Access Compliance Report Public Rights-of-Way (Curb Ramps)

Main Street: FLIGHT_AVE Cross Street: VAN_BUREN_ST Location: SE

ADA ID: RPRK210930125031 Ramp Type: Type 1 - Perpendicular Diagonal Initial Pass/Fail: Fail Overall Compliance: No Severity Score: 2

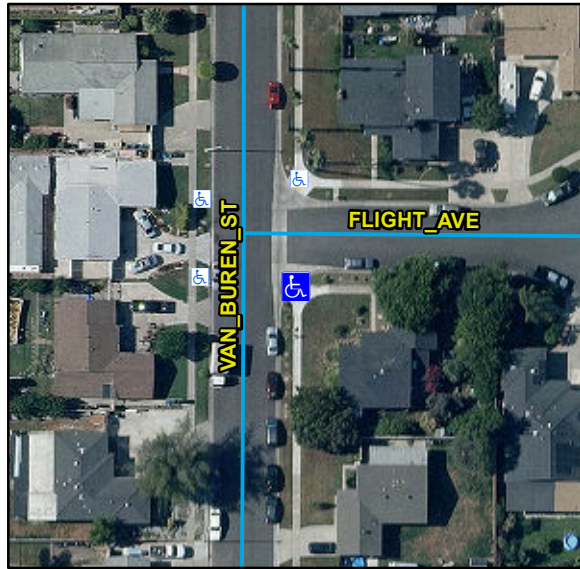
Compliance	Description	Data	Compliance	Description	Data
N/A	Ramp Length (in)	128	N/A	Flare Type LT	
Yes	Ramp Width (in)	48			N/A
Yes	Ramp Run Slope (%)	6.5	N/A	Flare Slope LT (%)	N/A
No	Ramp Cross Slope (%)	4.7	N/A	Flare Traversable LT	N/A
N/A	Landing Present	N/A	N/A	Flare Type RT	
N/A	Landing Length (in)	N/A			N/A
N/A	Landing Width (in)	N/A	N/A	Flare Slope RT (%)	N/A
N/A	Landing Run Slope (%)	N/A	N/A	Flare Traversable RT	N/A
N/A	Landing Cross Slope (%)	N/A	N/A	DWS Provided	N/A
N/A	Landing Movement Obstructed?	N/A	N/A	DWS Contrast	N/A
	Landing Movement Type	N/A	N/A	DWS Length (in)	N/A
N/A	Landing Shared	N/A	N/A	DWS Full Width	N/A
N/A	Clear Space	Yes	N/A	DWS Offset Left (in)	N/A
N/A	Clear Space To Crosswalk (in)	N/A	N/A	DWS Offset Right (in)	N/A
N/A	Marked Crosswalk 1	No	N/A	Marked Crosswalk 2	No
	Crossing 1 Direction	N		Crossing 2 Direction	W
	Marked Crosswalk 1 Width (in)	N/A		Marked Crosswalk 2 Width (in)	N/A

N/A	Ramp Inside Crosswalk 1	N/A	Yes	Ramp Inside Crosswalk 2	N/A
	Crossing 1 Slope (%)	2.3		Crossing 2 Slope (%)	5.3
	Crossing 1 Cross Slope (%)	0.6		Crossing 2 Cross Slope (%)	2.1
N/A	Gutter Ponding	N/A	N/A	Curb Slope	3.6
Yes	Gutter Lip Height (in)	0		Road Run Slope (%)	3.1
N/A	Gutter Run Slope (%)	N/A		Road Cross Slope (%)	1.2
N/A	Gutter Cross Slope (%)	N/A			
Yes	Overall Surface Condition: Acceptable		Yes	Perp Joint Present	Yes
	Cross Gutter Present?	Yes		Spandrel Present?	Yes
	Replace Cross Gutter?	No		Replace Spandrel?	No

Remove & Replace Curb Ramp With Two New Directional Ramps or Equivalent.

R304.5.3, STD 1115
